(12) **United States Design Patent** (10) **Patent No.:** **US D877,930 S**  
**Santamarta** (45) **Date of Patent:** **\*\* Mar. 10, 2020**

(54) **CONTAINER**

UNITED STATES PATENT AND TRADEMARK OFFICE  
**CERTIFICATE OF CORRECTION**

PATENT NO. : D877,930 S  
APPLICATION NO. : 29/672508  
DATED : March 10, 2020  
INVENTOR(S) : Santamarta

*FIG. 1*

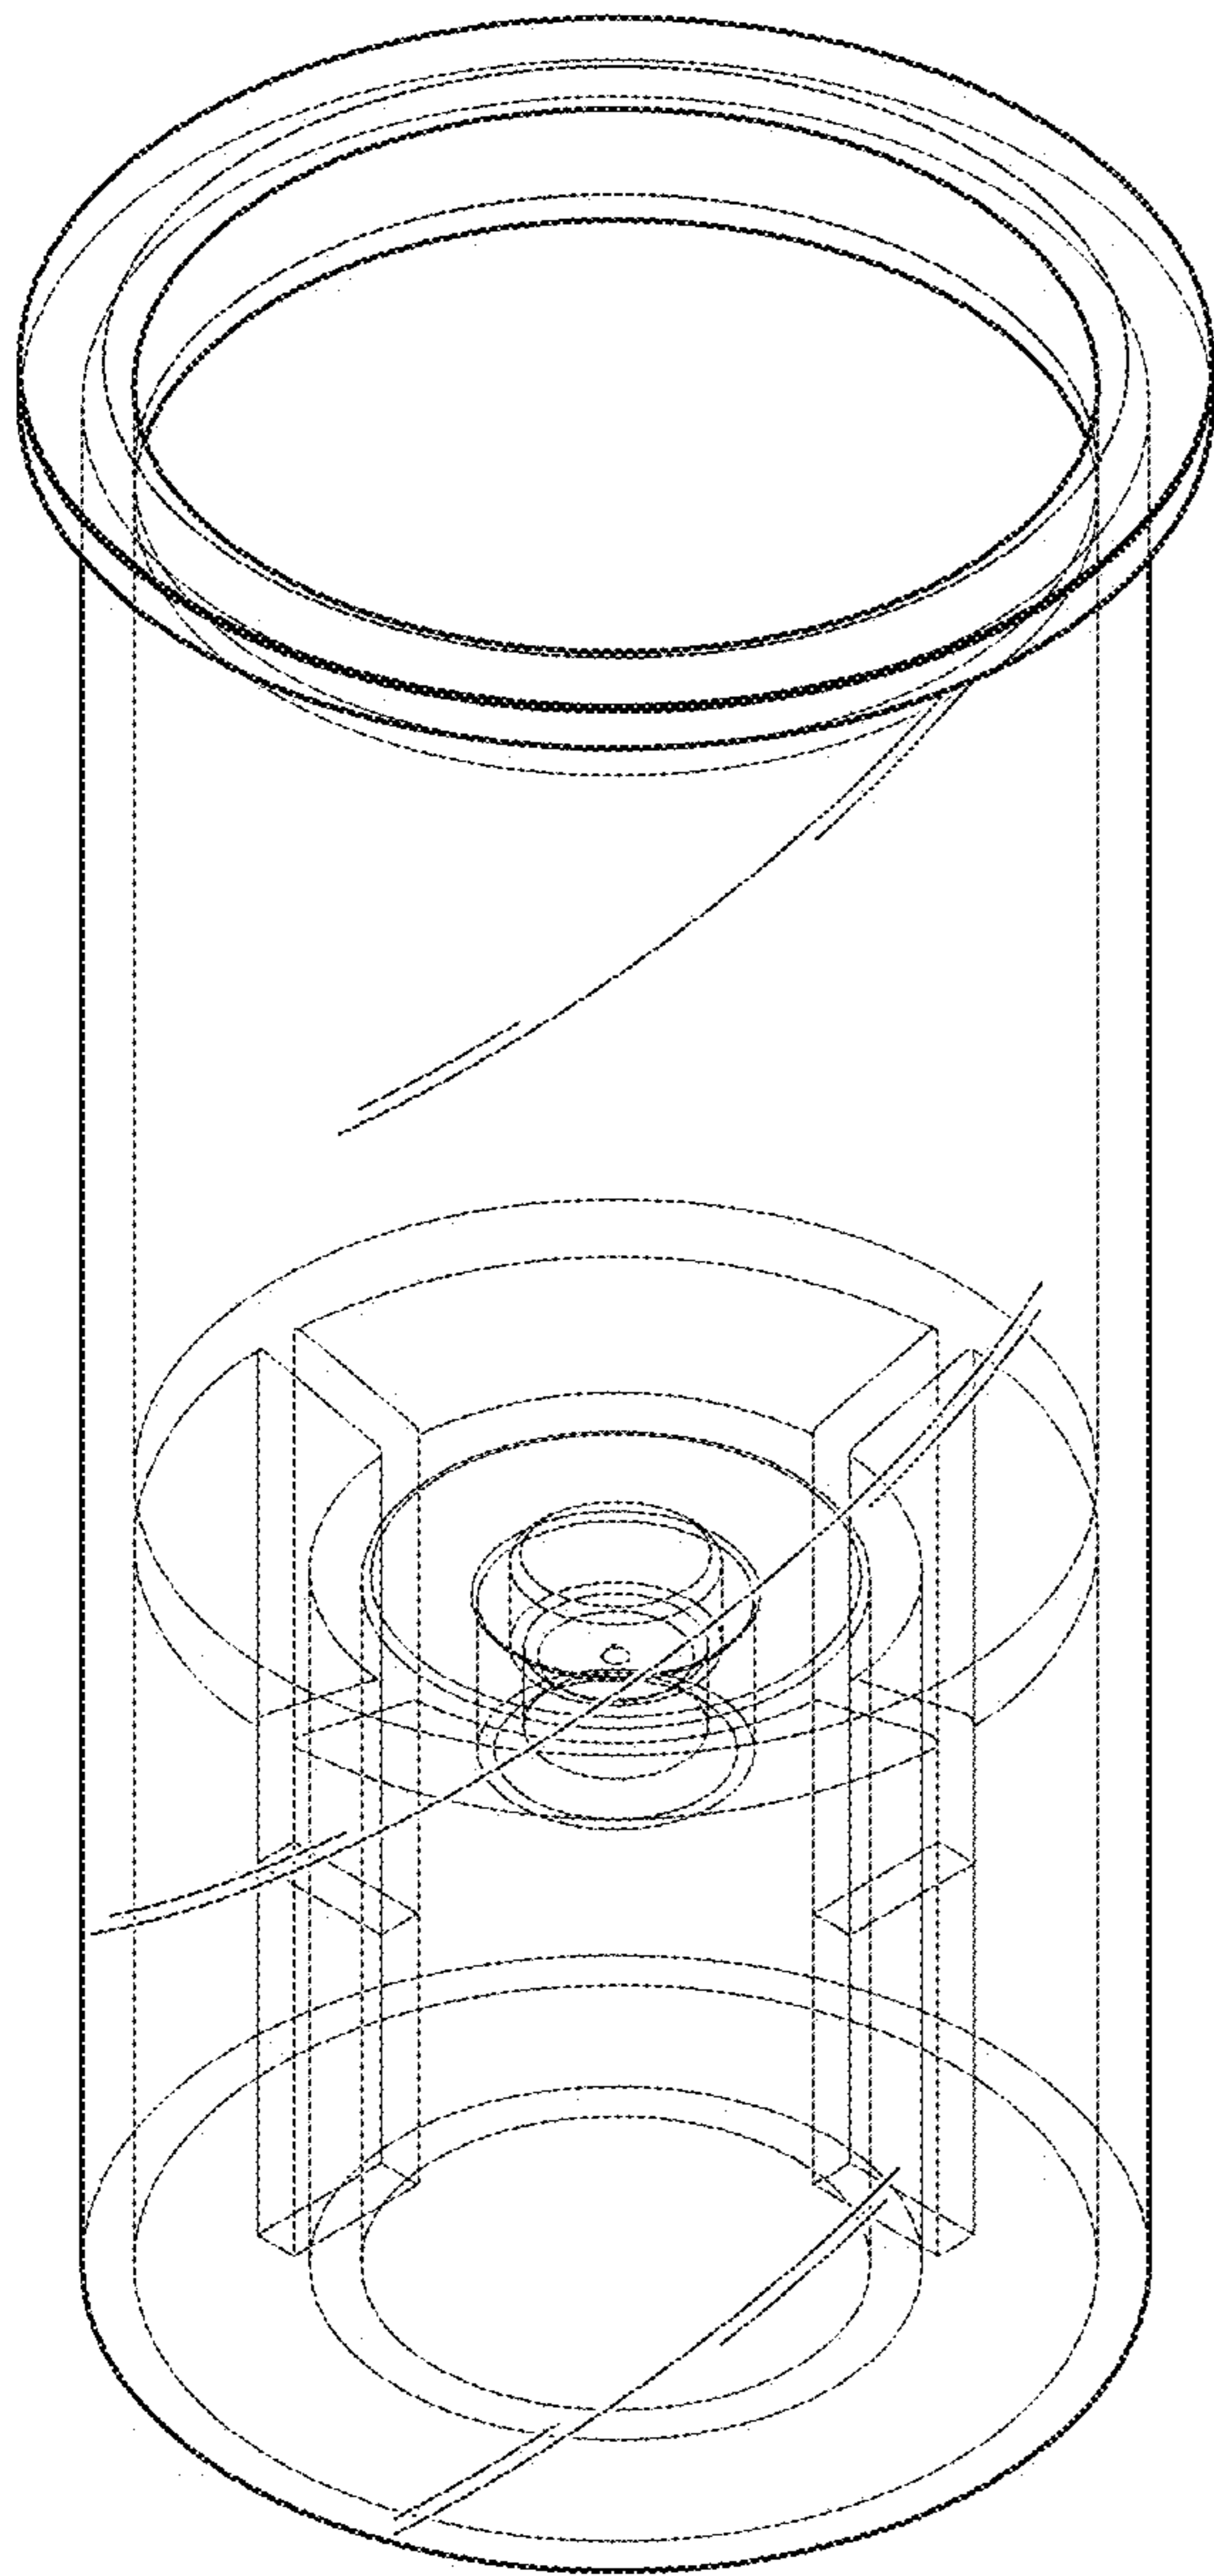
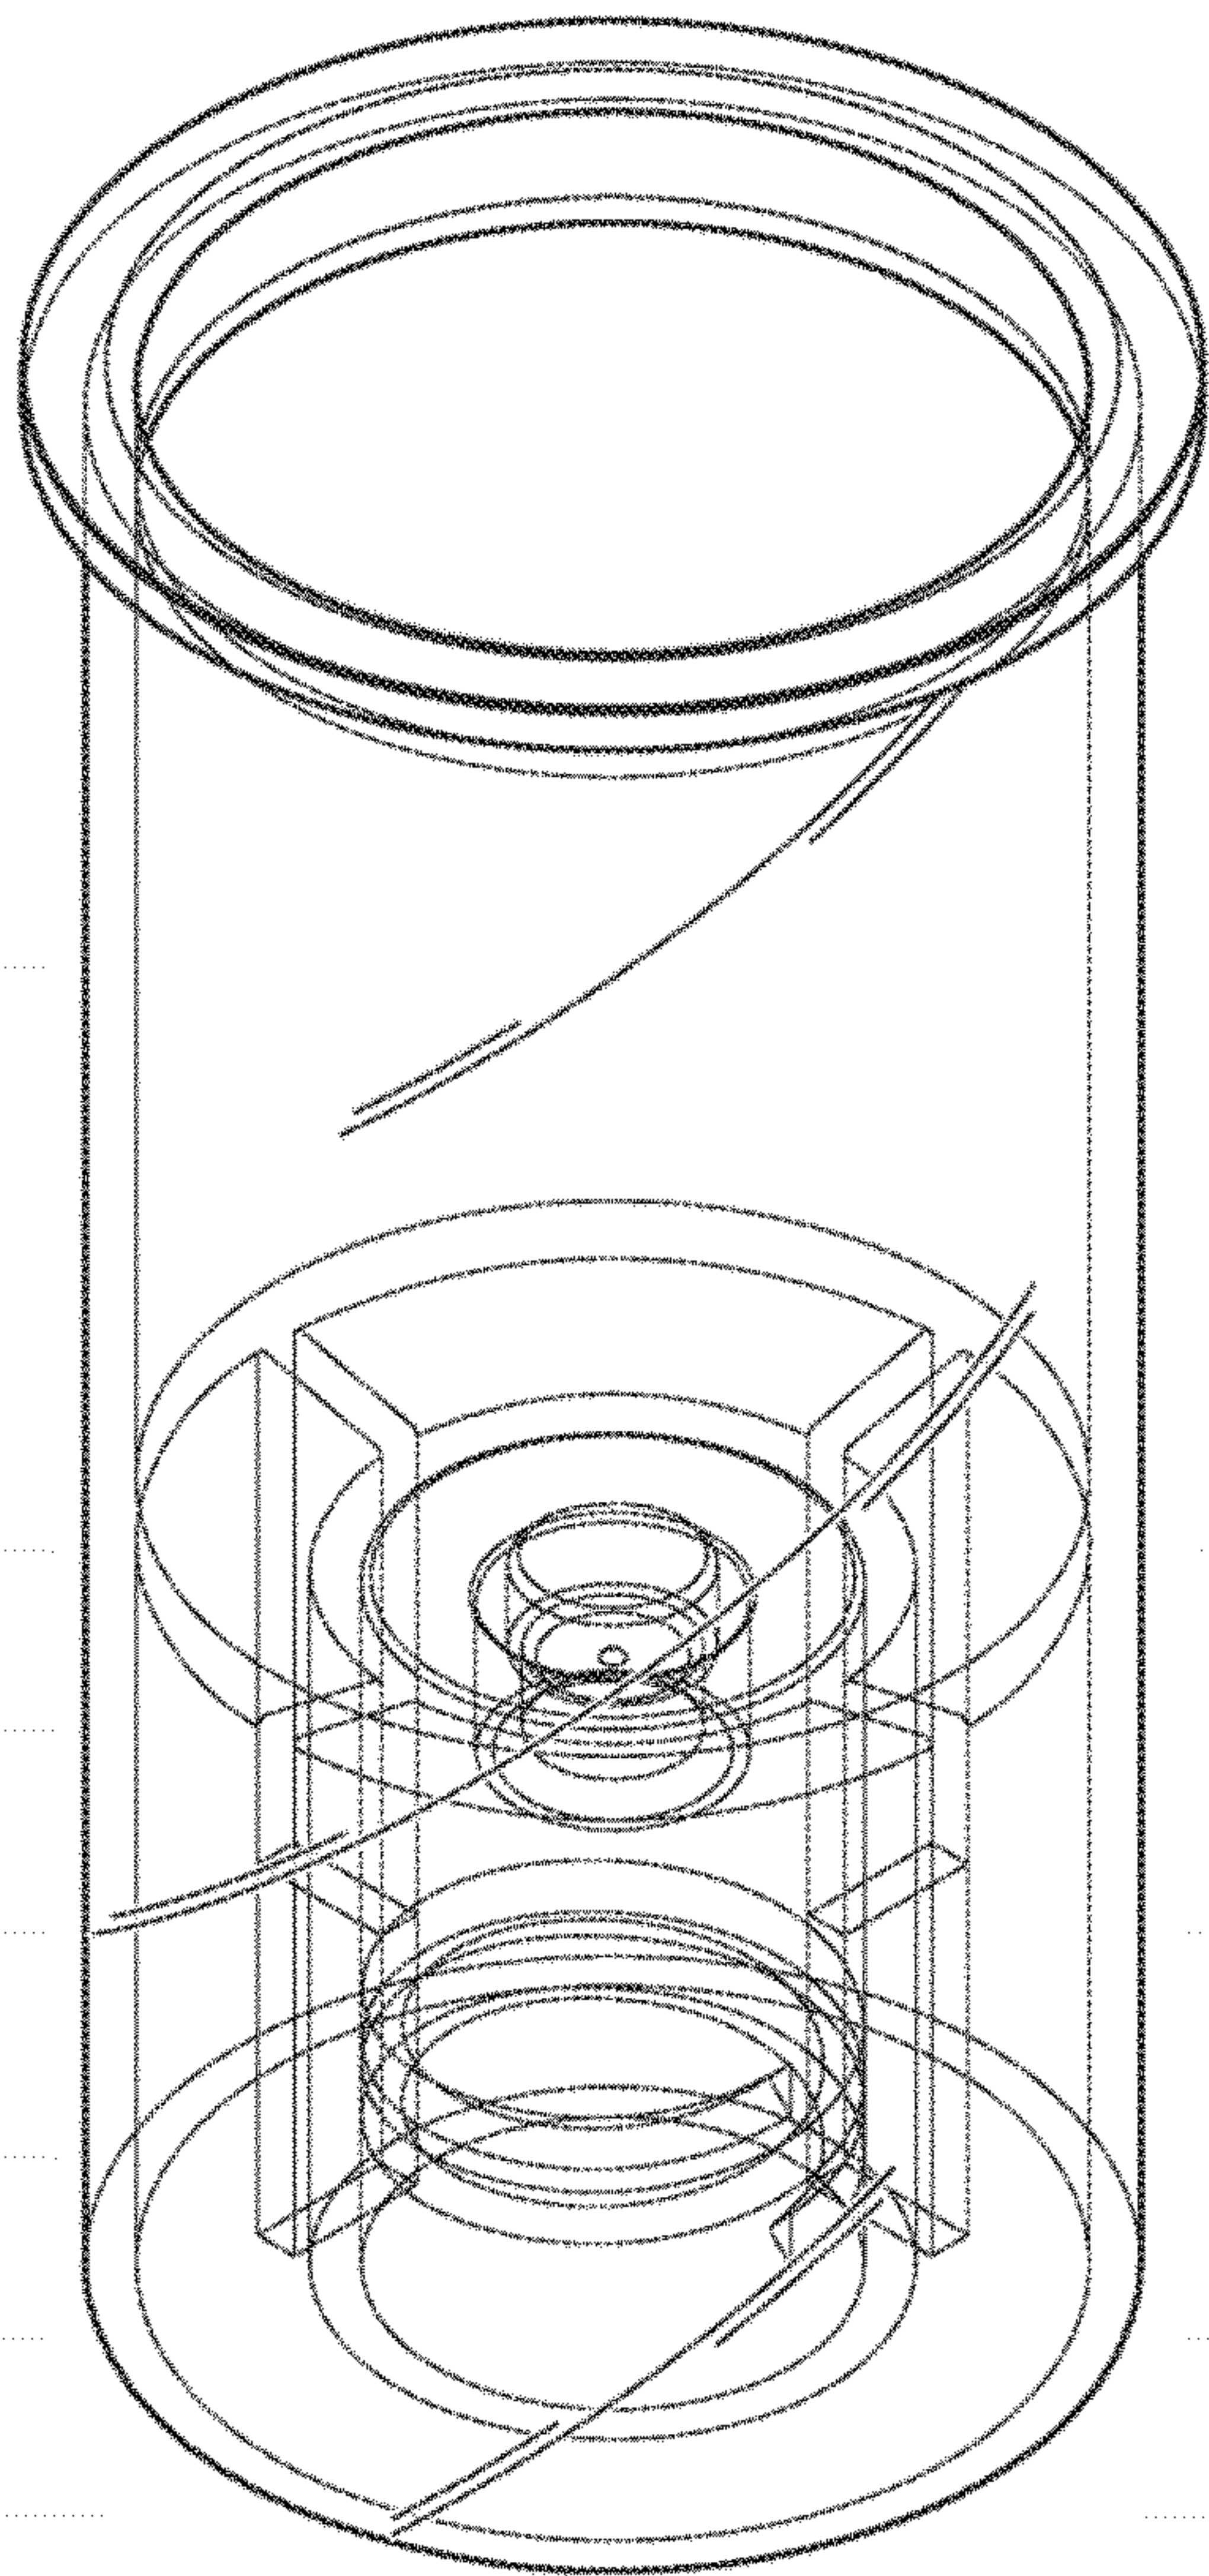
The error in Fig. 1 in which threading should be included near the bottom to reflect what is shown in Figs. 3 and 6.

In Fig. 1, threading should be included near the bottom to reflect what is shown in Figs. 3 and 6 as shown on the attached drawing sheet.
